Coastal Access Modification Report GAL-MR2

Proposed changes to the submitted England Coast Path proposals for Gretna to Allonby

Location affected: Raby Cote/Raby Grange, Abbeytown, Cumbria

Natural England's Modification Report to the Secretary of State

Map GAL-MR2a - Raby Cote

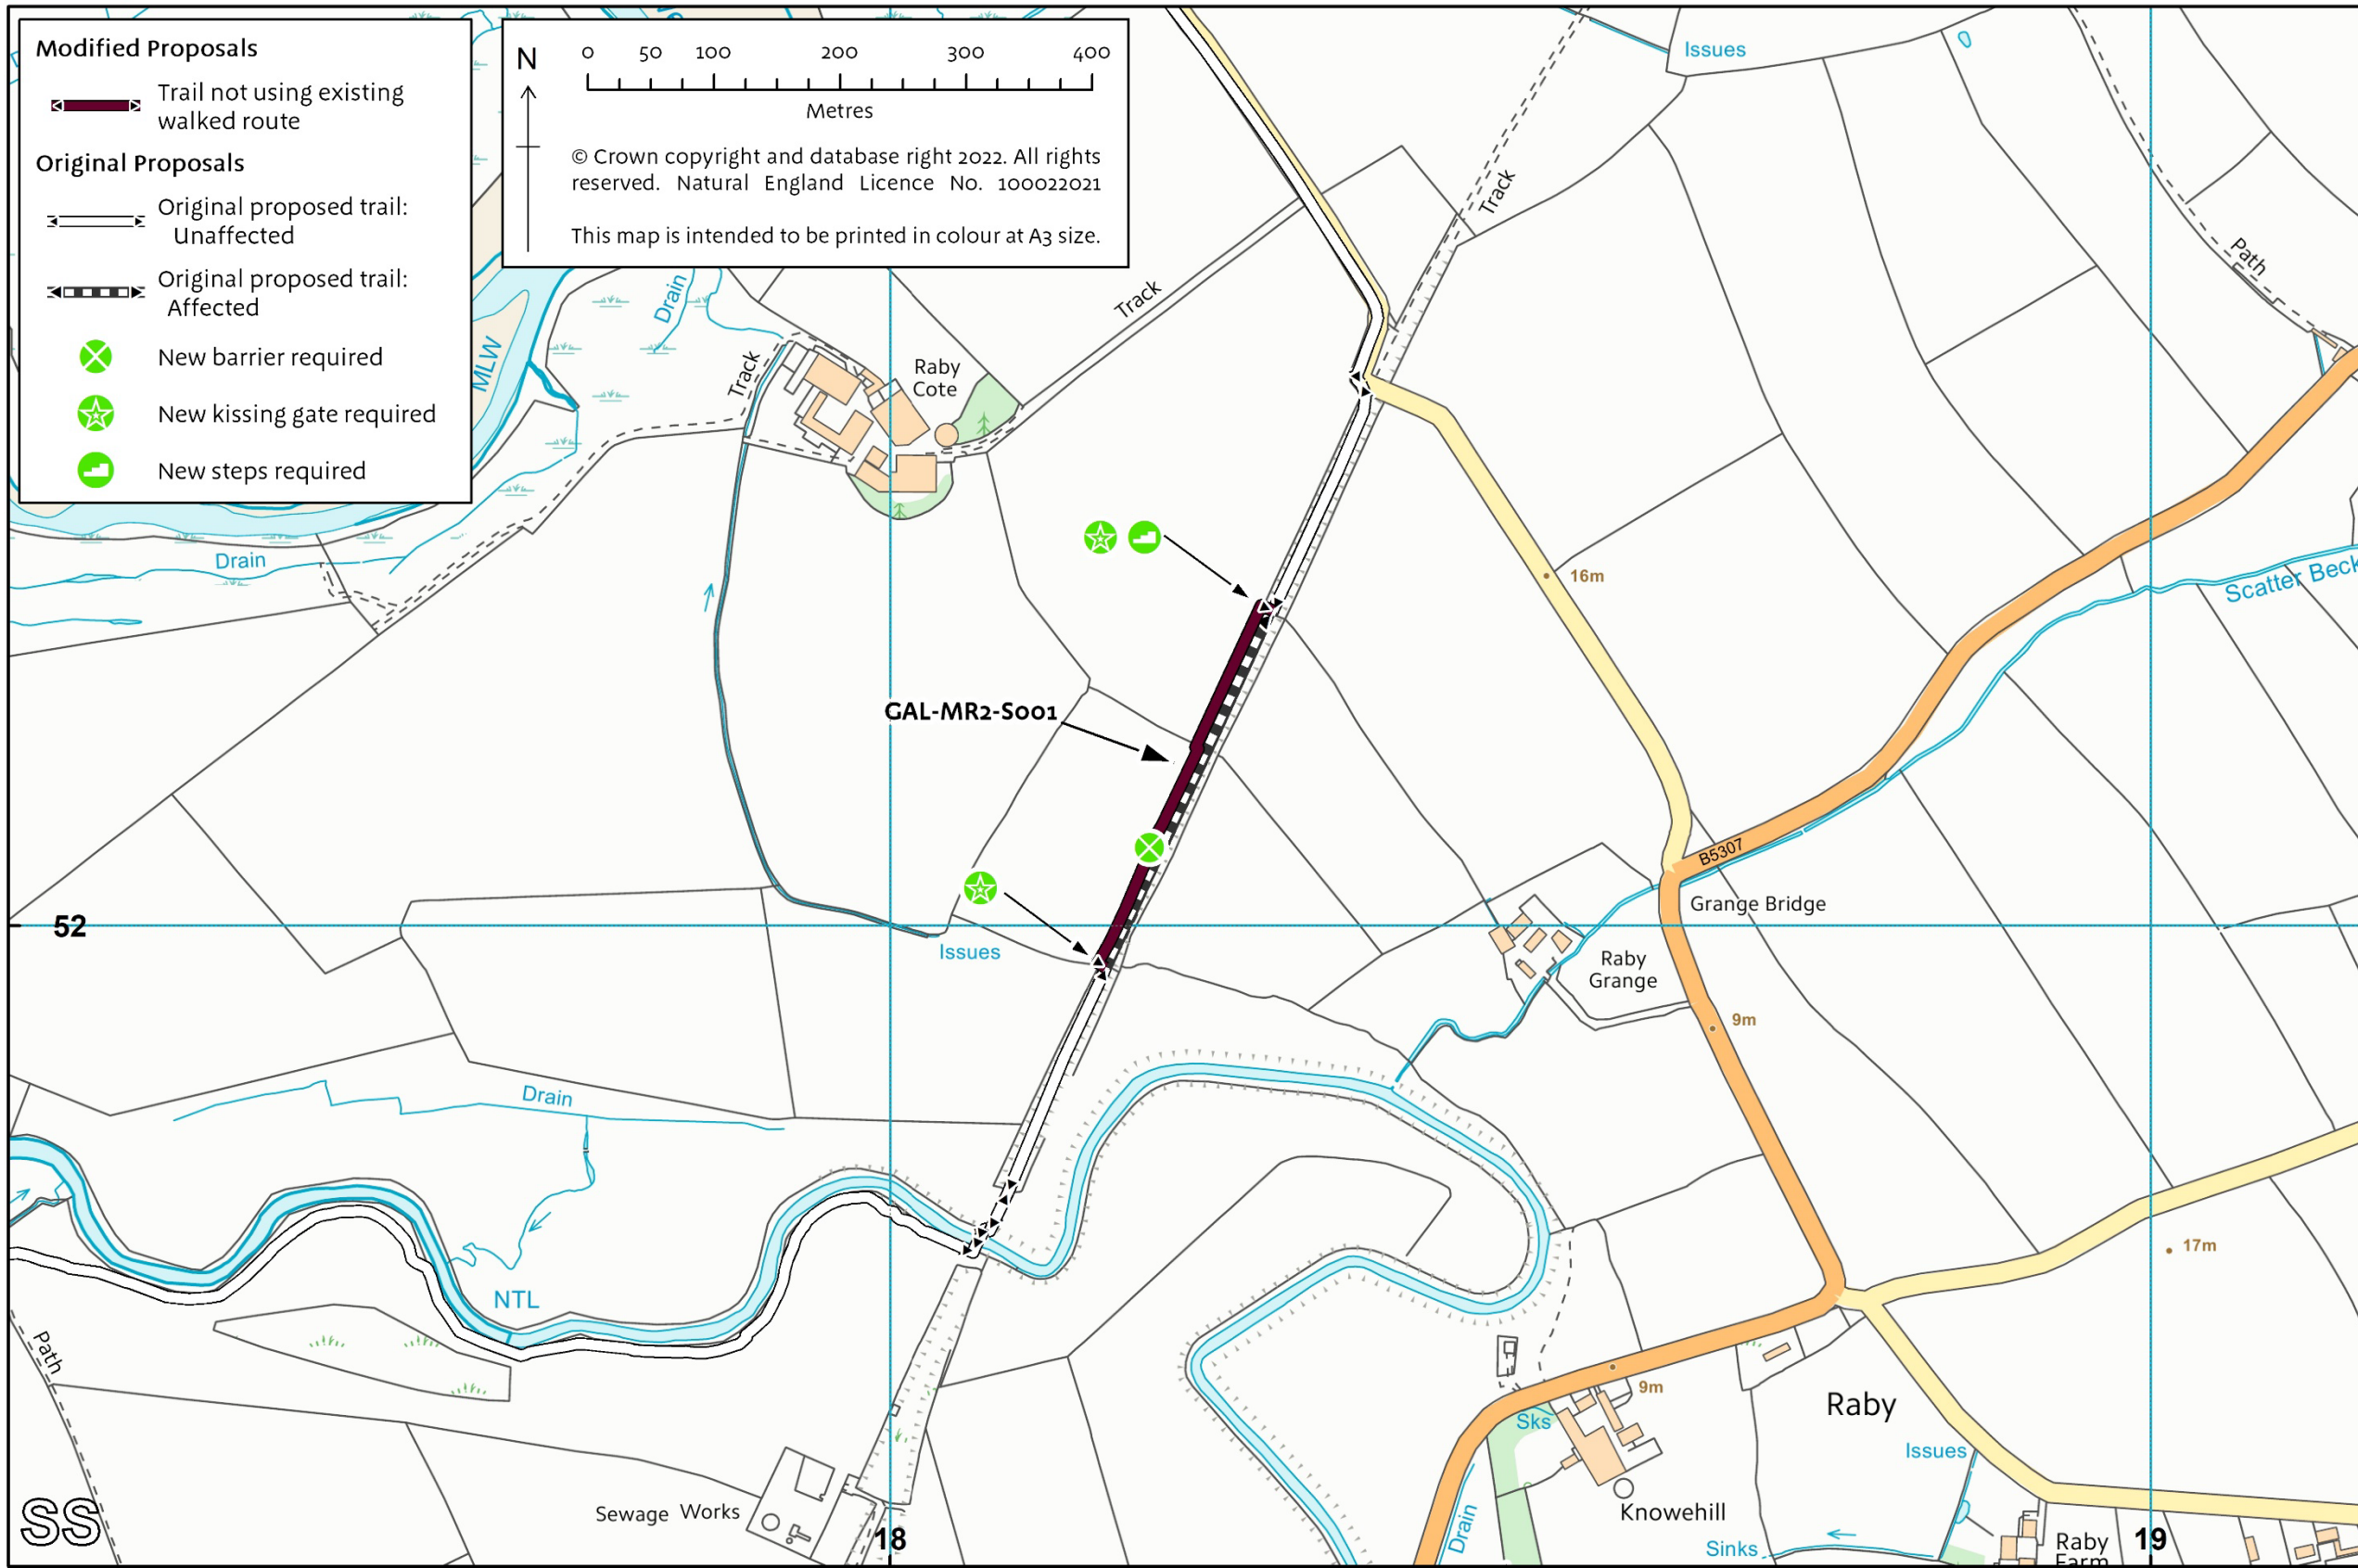
A.2.1 Our proposal (see map GAL-MR2a) is, from north to south, to re-route the path shown as the northern part of section GAL-4-S018 in our original report. The realigned trail would extend for an approximate length of 310 metres at a maximum of 15 metres westward of the original route proposed.

A.2.2 The revised route would follow a newly constructed path parallel to and immediately west of the disused railway, as indicated by section GAL-MR2-S001 on map GAL-MR2a. At either end of the revised section, the route remains as proposed originally.

Map GAL-MR2b - Raby Cote - Key Statutory Environmental Designations

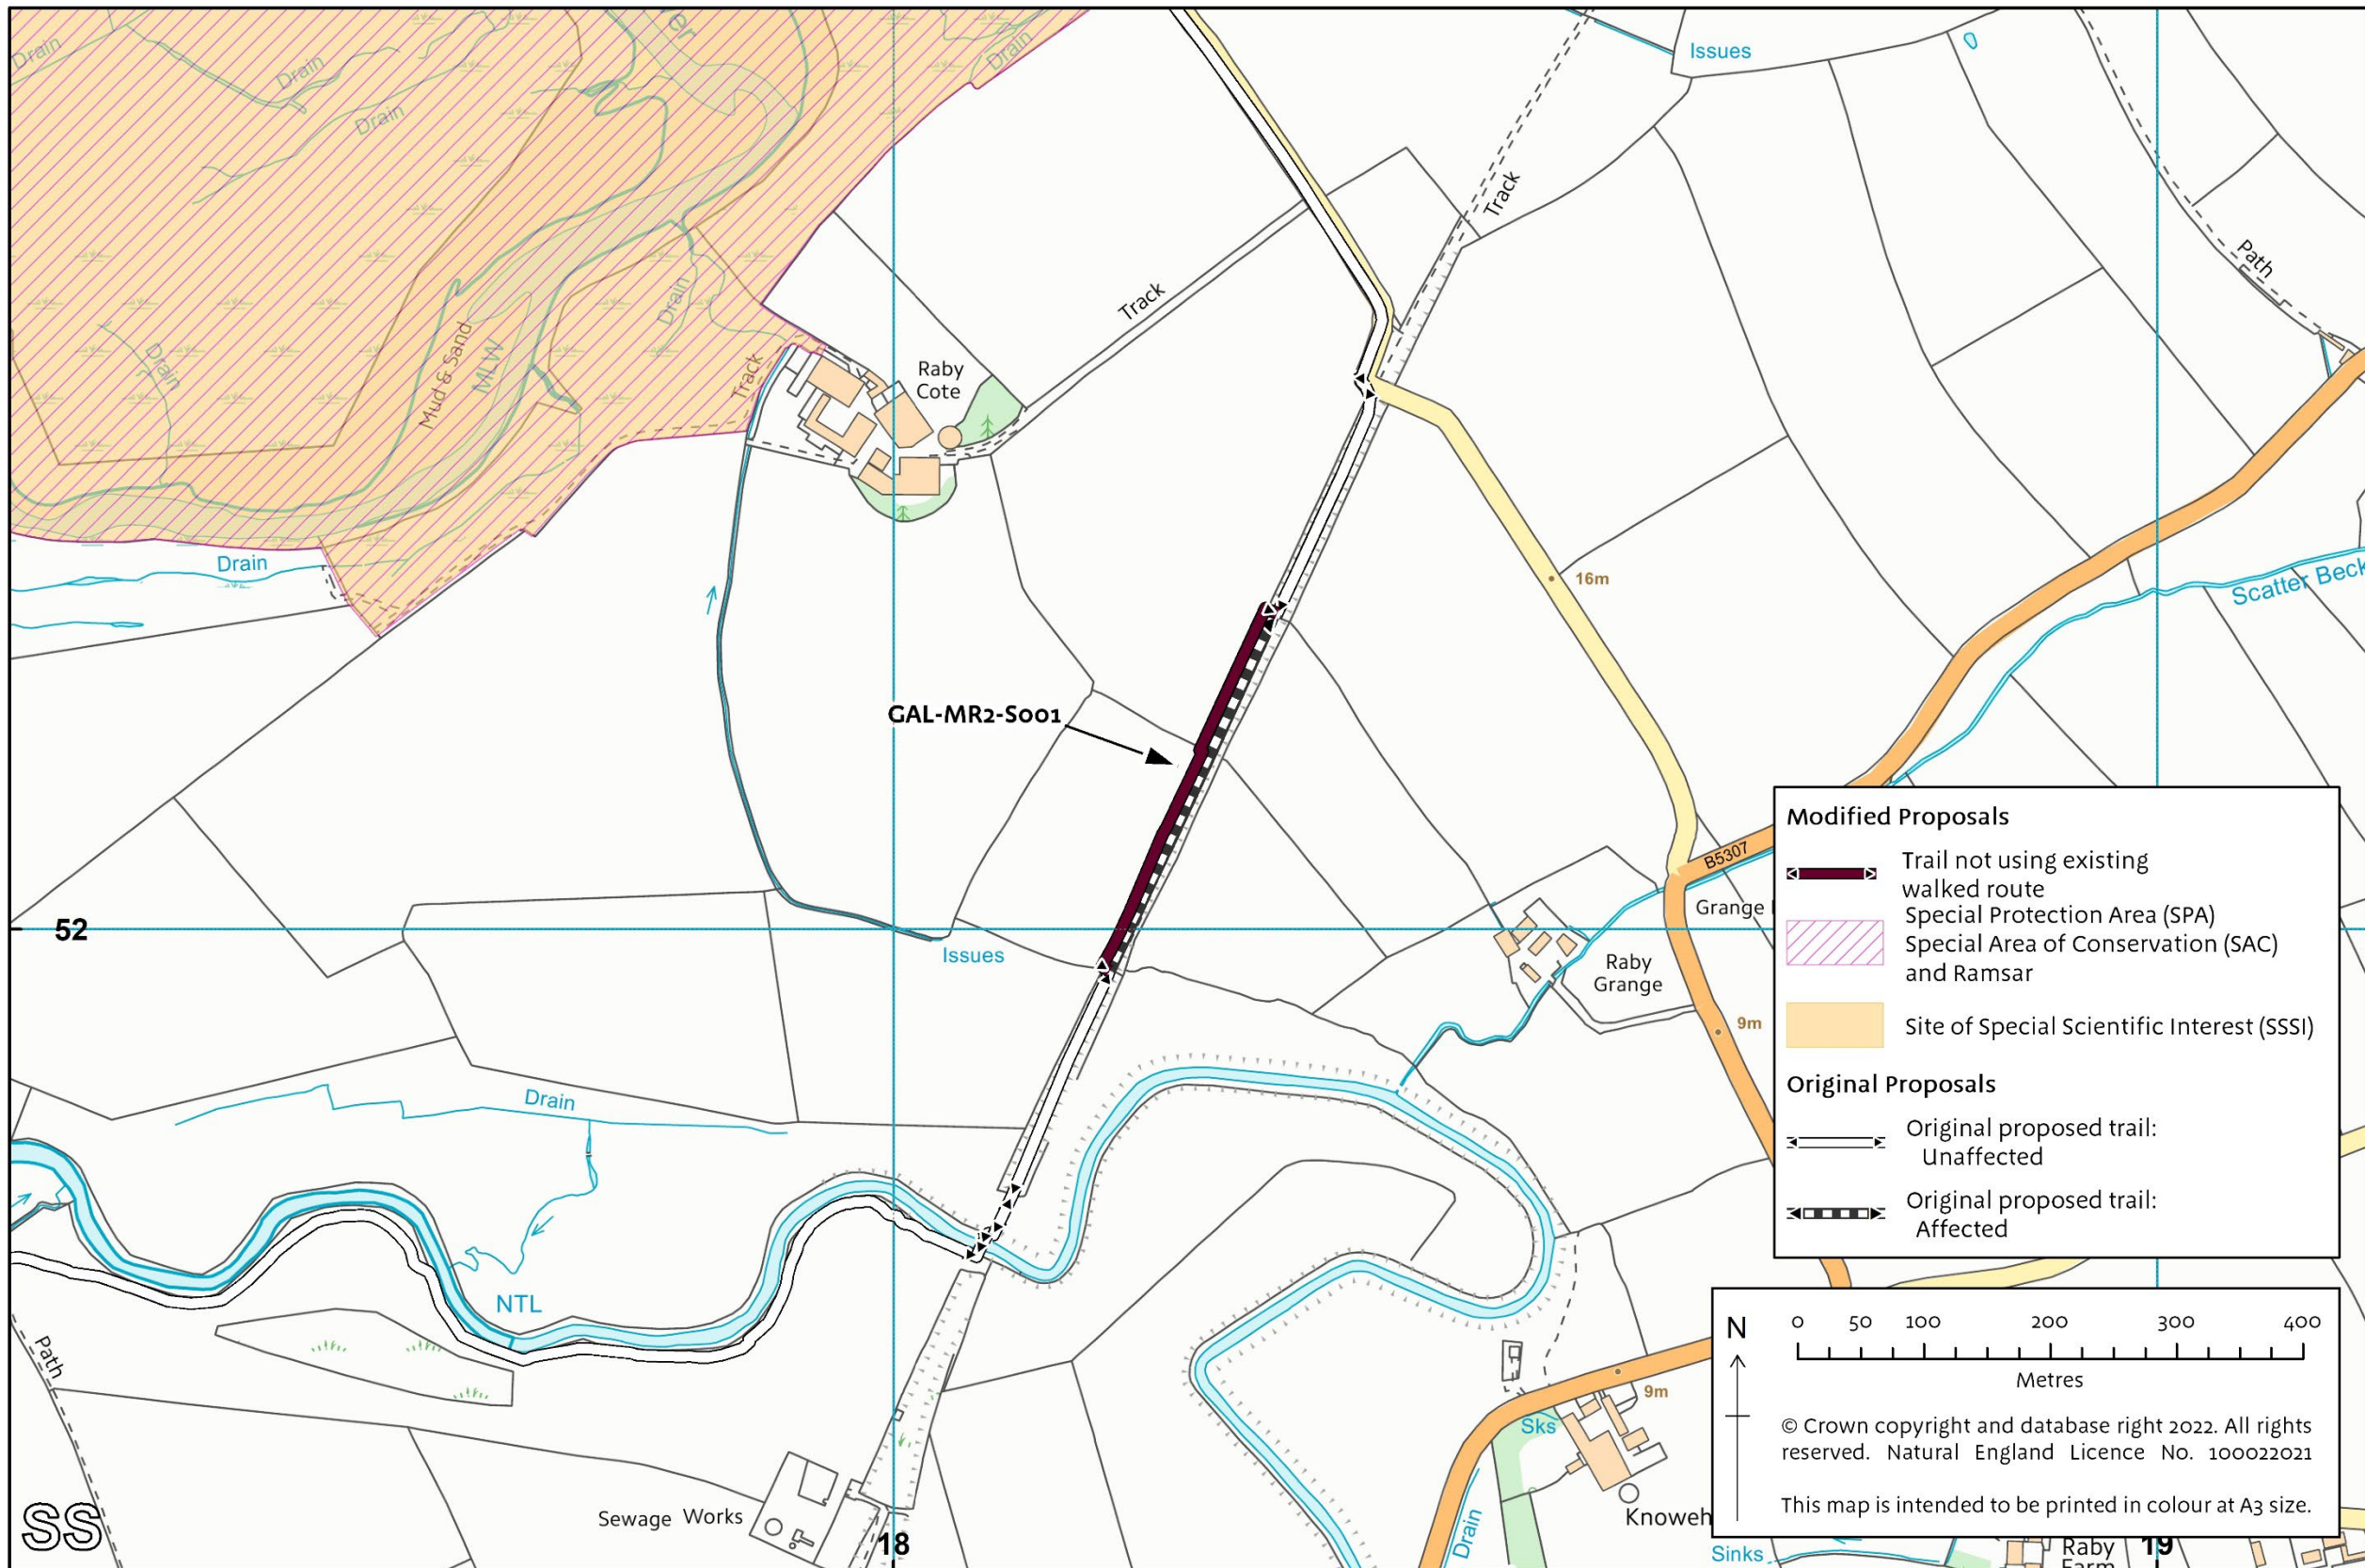
A.2.4 This proposed route passes through fields which are close to the Solway Firth SPA and Upper Solway Flats & Marshes Ramsar site / SSSI. Non-breeding bird features of these designated sites

(barnacle and pink footed geese) use these fields in large numbers. Walkers and dogs can cause disturbance to these features. Where the proposed route is aligned at the edge of fields, we will install a stock proof fence to reduce the risk of disturbance. The fence will be maintained by the access authority or a trail partnership.

Map GAL-MR2c - Raby Cote - Restrictions and Exclusions

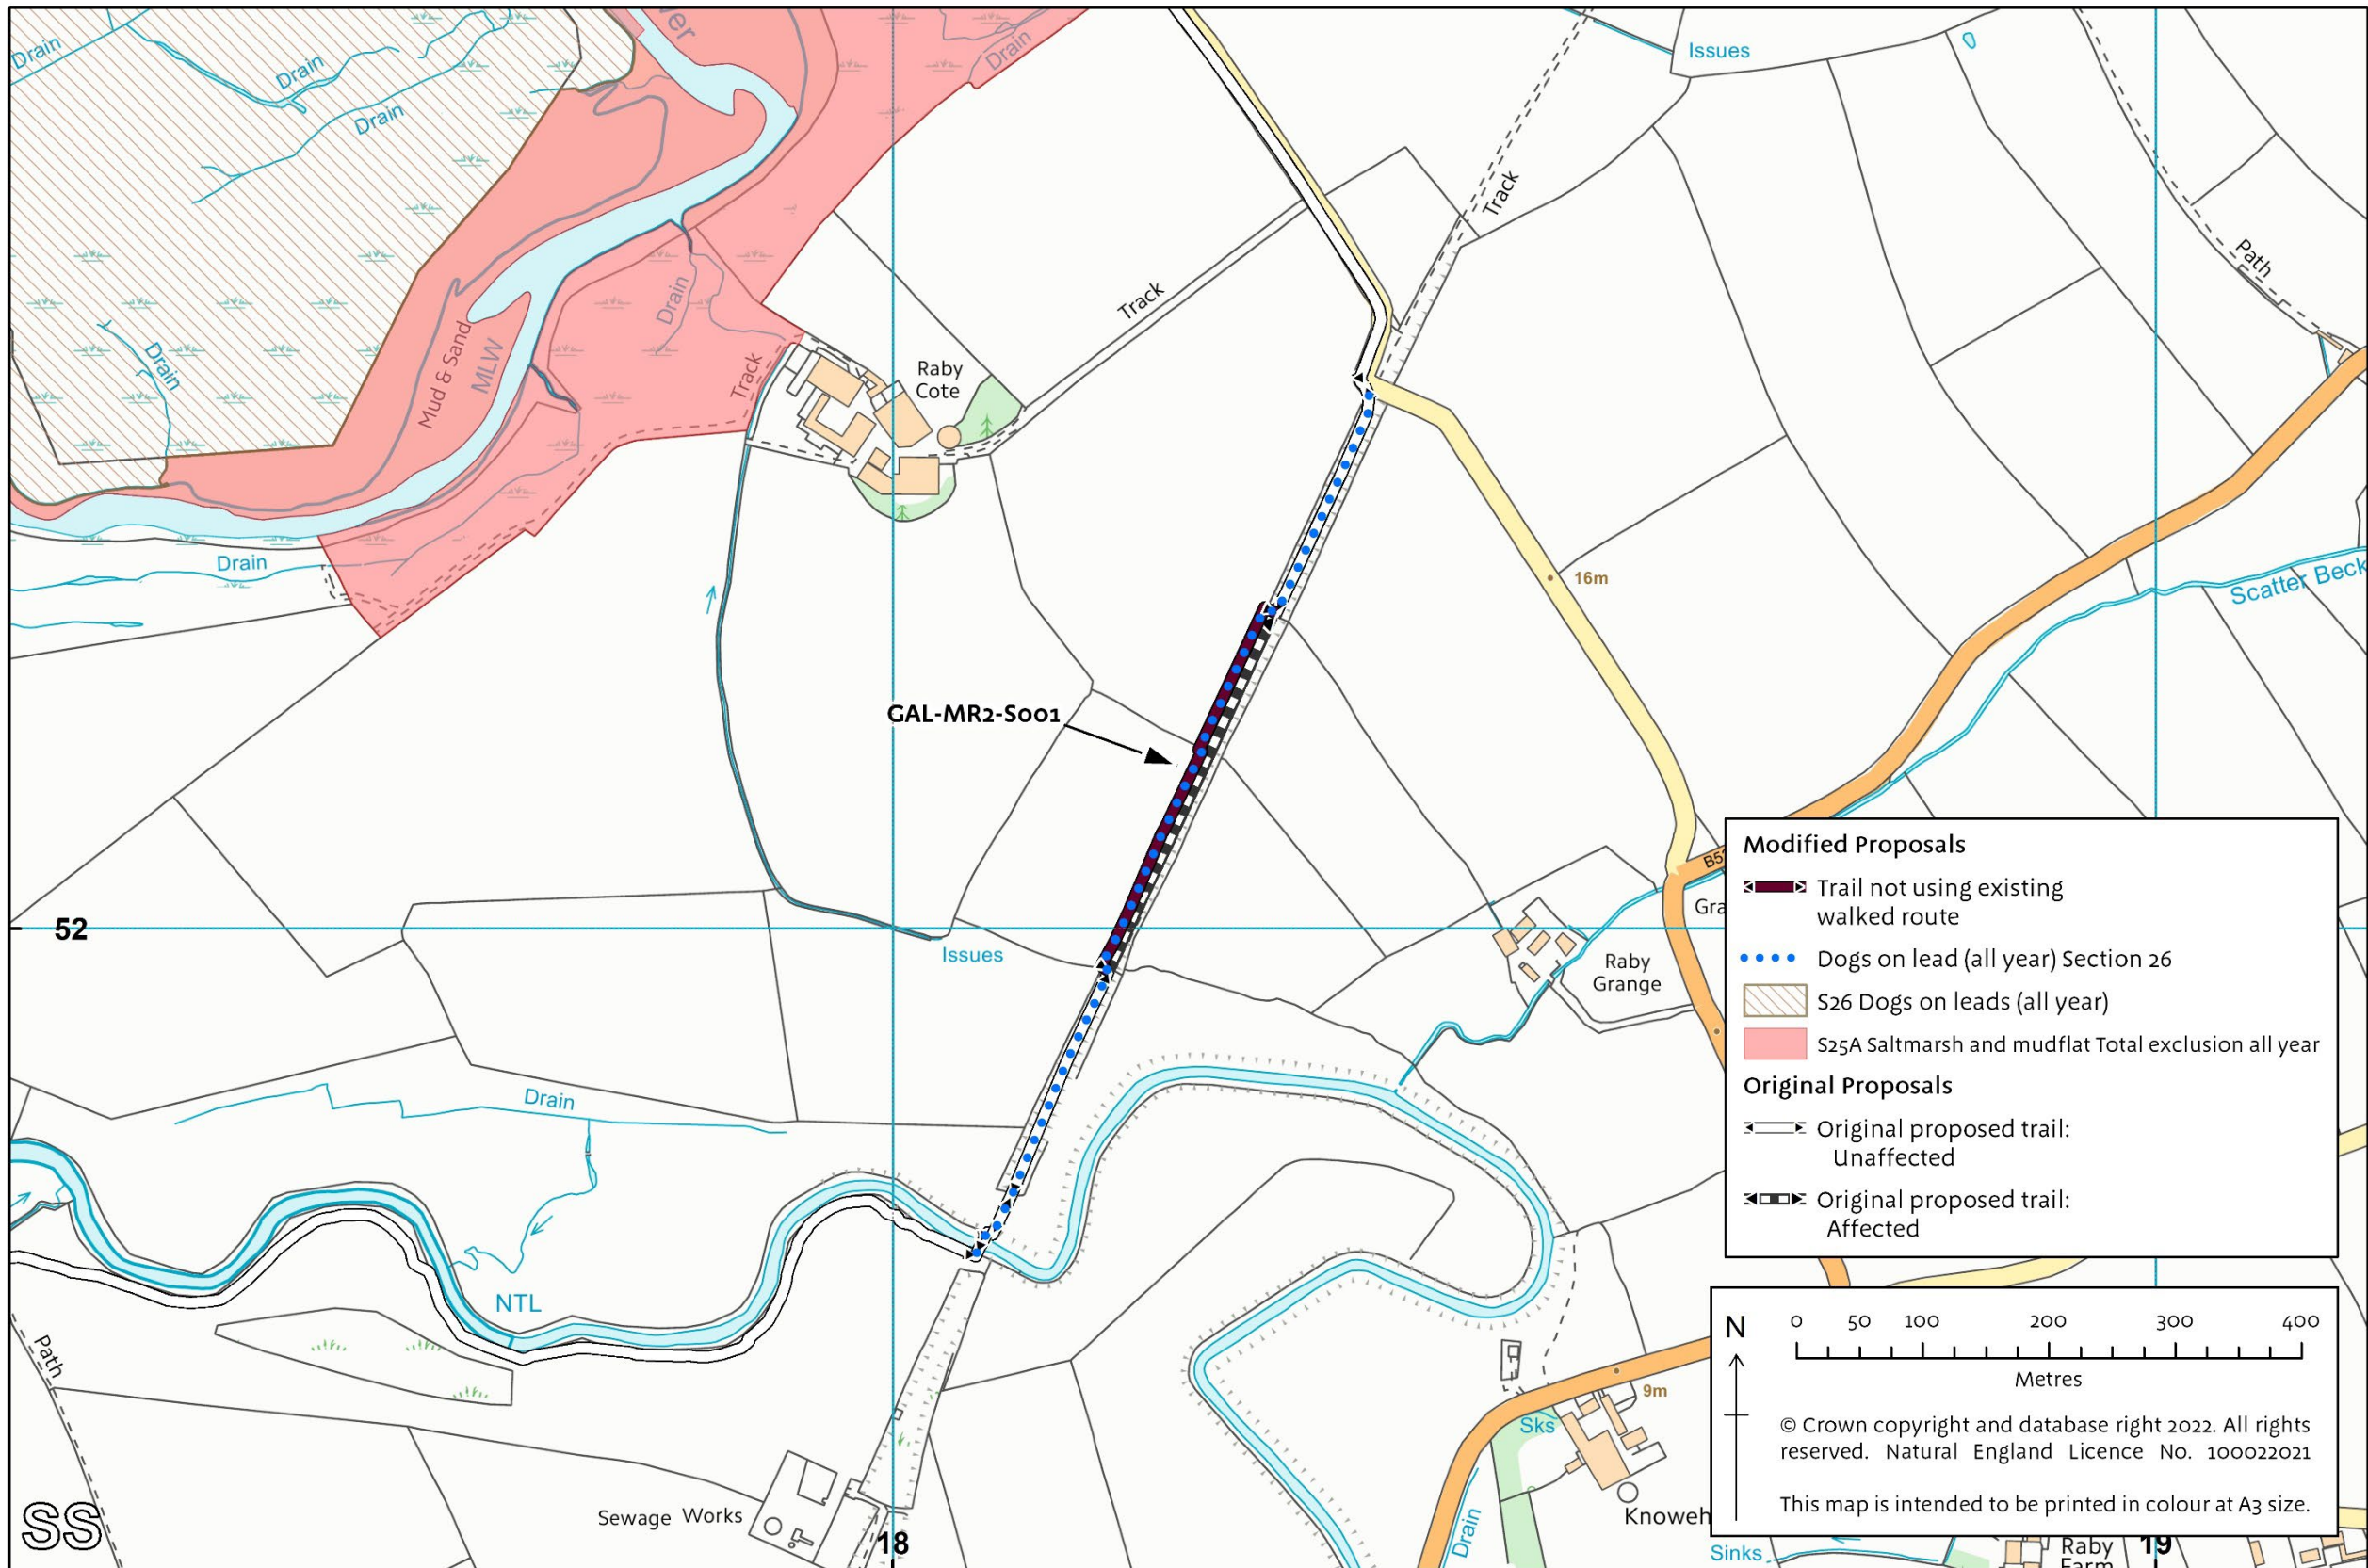
A.2.9 Access rights to the seaward margin would be subject to the excepted land rules and the national restrictions on coastal access rights. Proposed directions to exclude access affecting parts of the coastal margin in this vicinity remain as proposed in the original report.
